Proposed TMDL for Mercury in the Sacramento San Joaquin River Delta

Technical Issues - Policy Consequences

Fatal flaw #1: Correlation is not causation

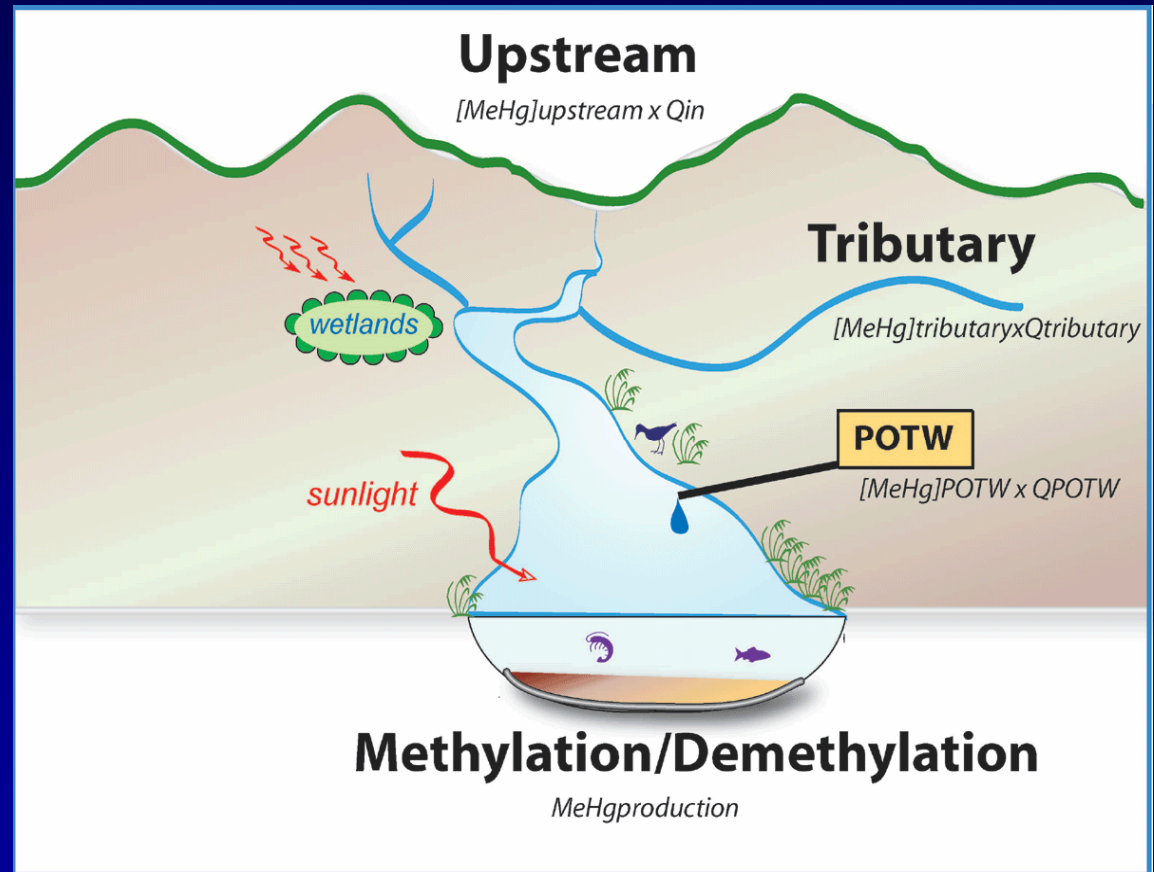
Report asserts high methylmercury in the water column causes high methylmercury in fish

Is this caused by this?

Reality is that both are caused by high rates of localized methylmercury production.

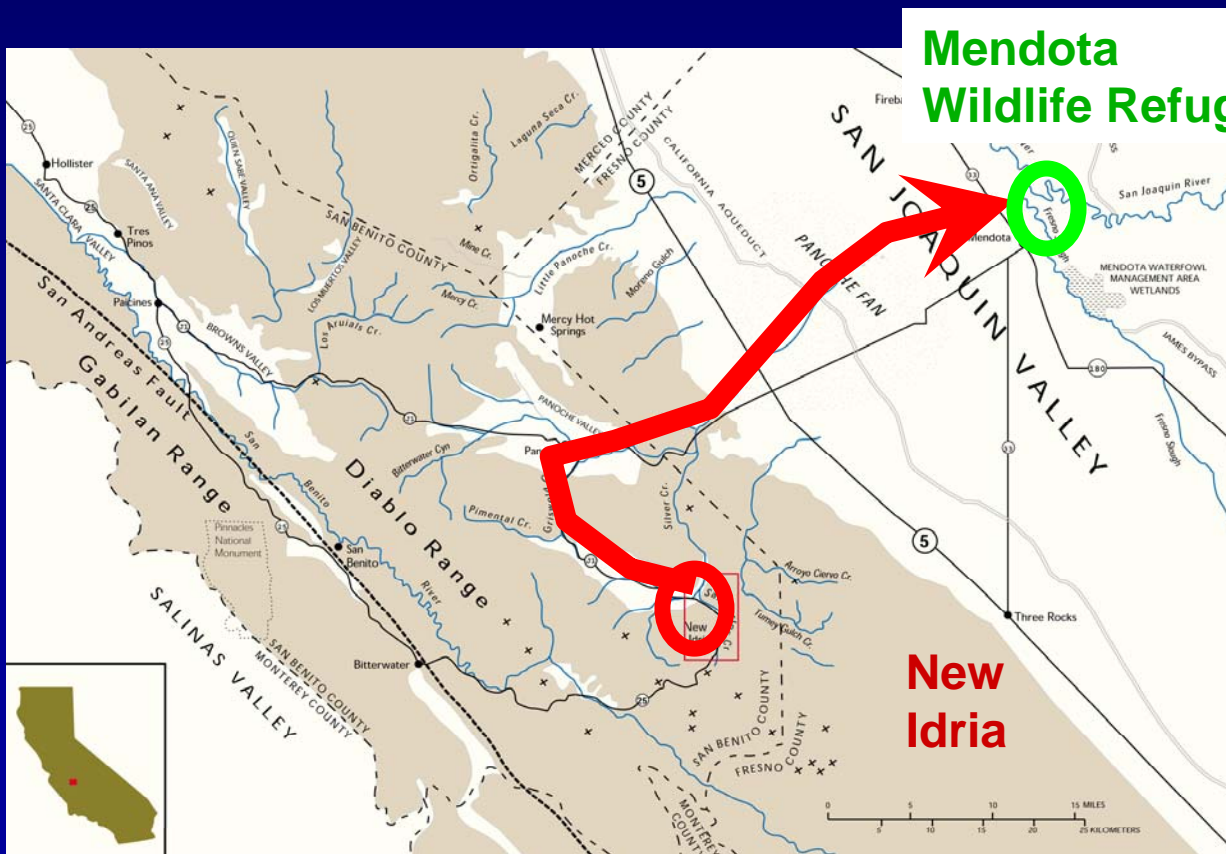
No, both are caused by THIS

Loads summary as presented to WEFTEC 2005, November 2, Washington D.C.

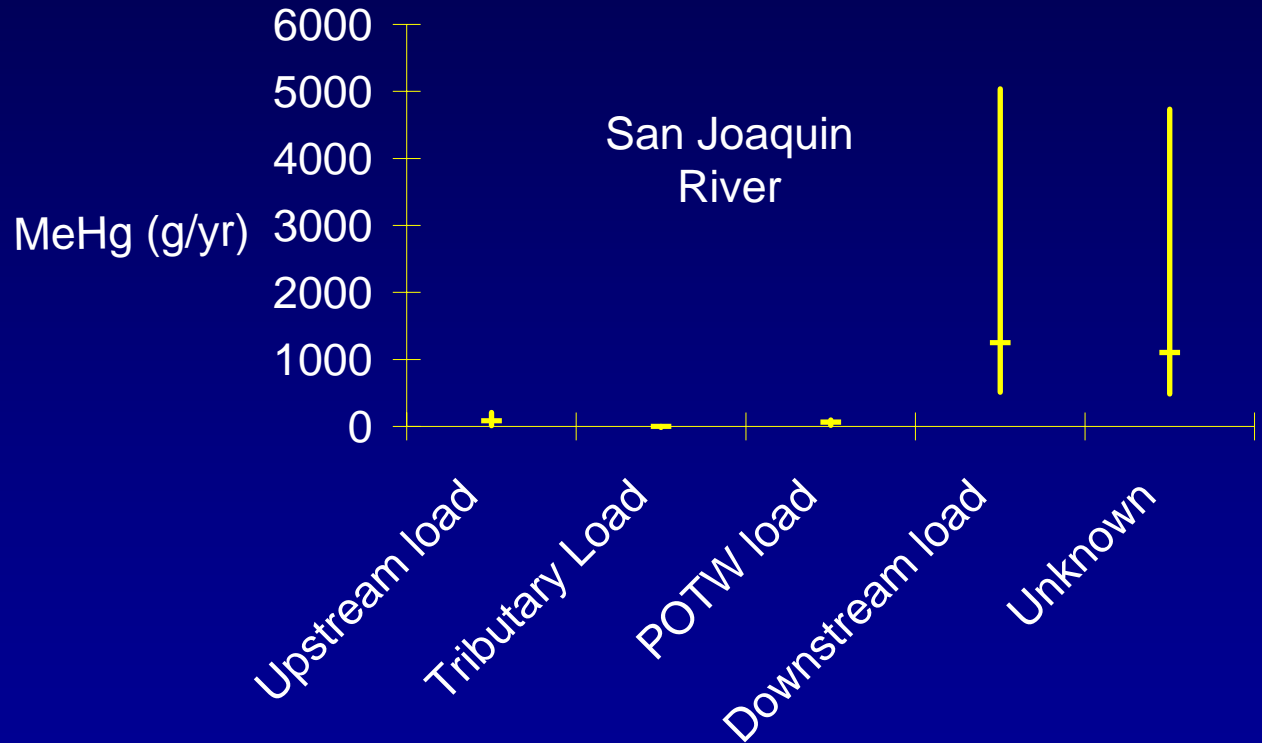
General point relevant to the Delta:

- Tributary loads, *in-situ* production cause too much methylmercury
- Not POTWs

Loads summary as presented to WEFTEC 2005, November 2, Washington D.C.

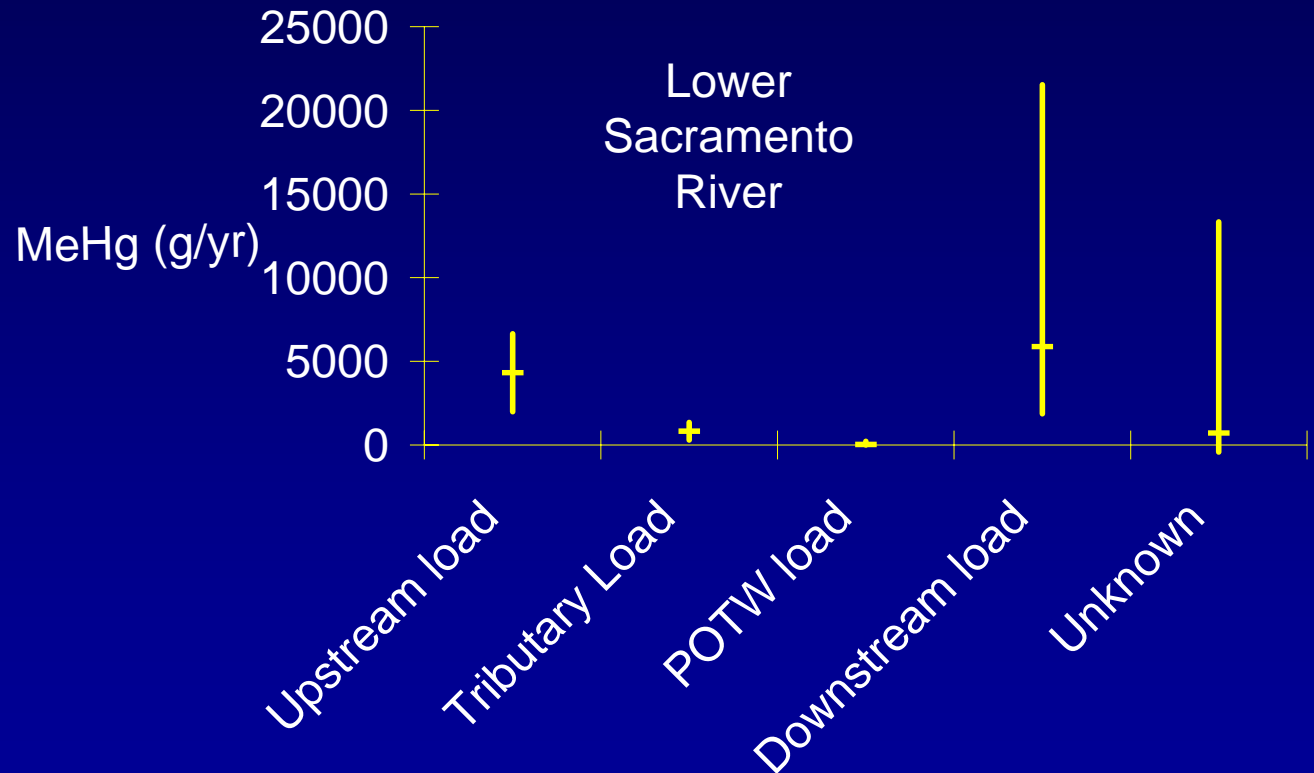
General point relevant to the Delta:

- Tributary loads, *in-situ* production cause too much methylmercury
- Not POTWs

Loads summary as presented to WEFTEC 2005, November 2, Washington D.C.

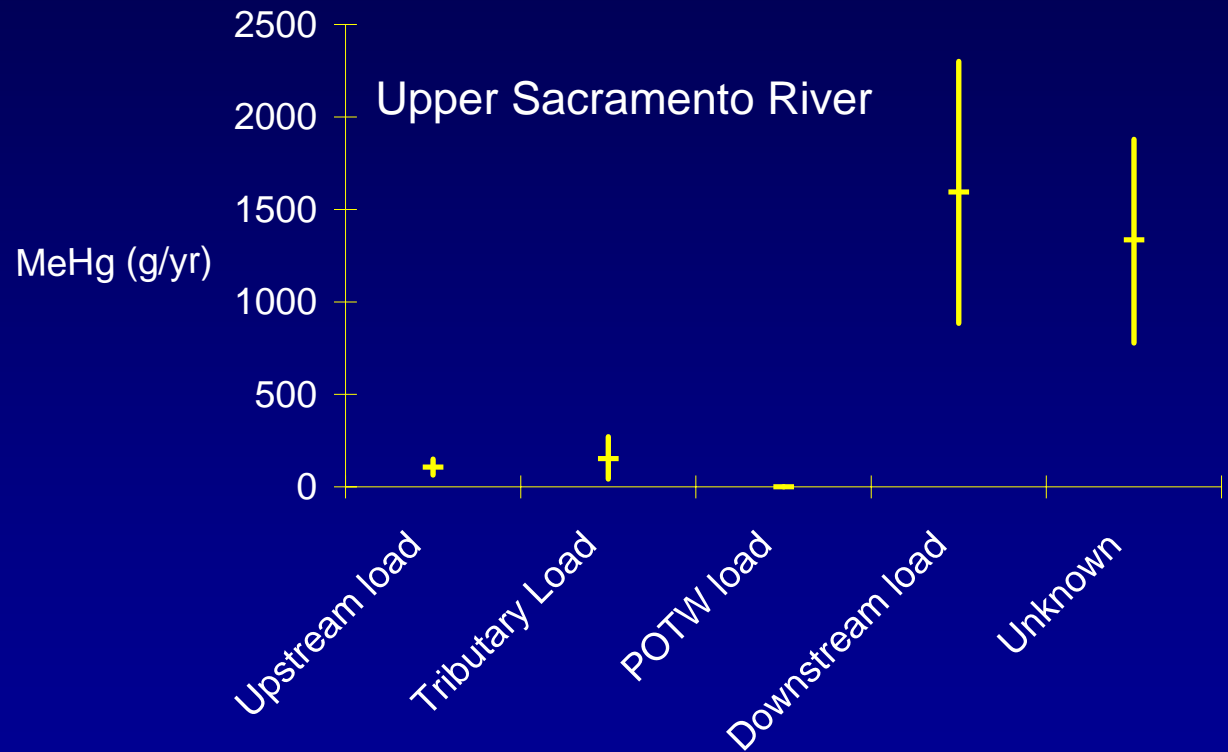
General point relevant to the Delta:

- Tributary loads, *in-situ* production cause too much methylmercury
- Not POTWs
